Access Compliance Report

Public Rights-of-Way

(Curb Ramps)

Intersection ID: 49196	Main Street: GIBBON_TERRACE_CT	Cross Street: GRAYPARK_DR	Location: SE
ADA ID: F26CFC5B9D1D	Ramp Type: BlendTrans1	Initial Pass/Fail: Fail	Overall Compliance: No
Severity Score: 33.75			
Codes/Mitigation Info/Possible Solution		Field Measurements/Component Compliance

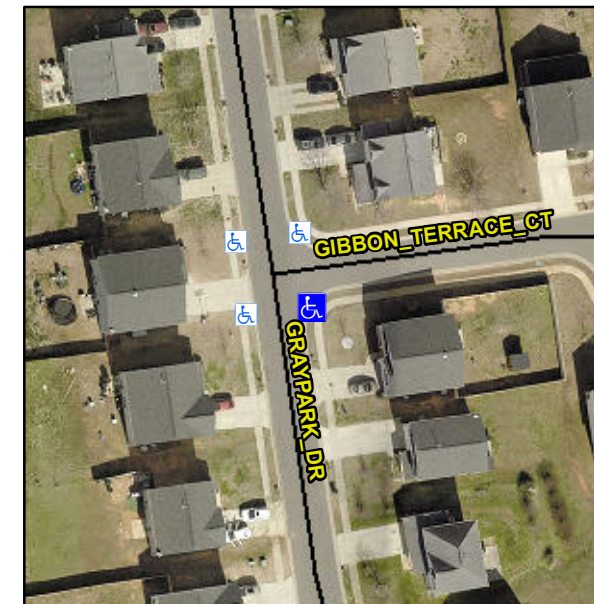
CURB GAP 1.0, LNDG LIP 0.5

Not Found, R304.5.1, R304.5.3

Remove & Replace Curb Ramp With Two New Directional Ramps or Equivalent.
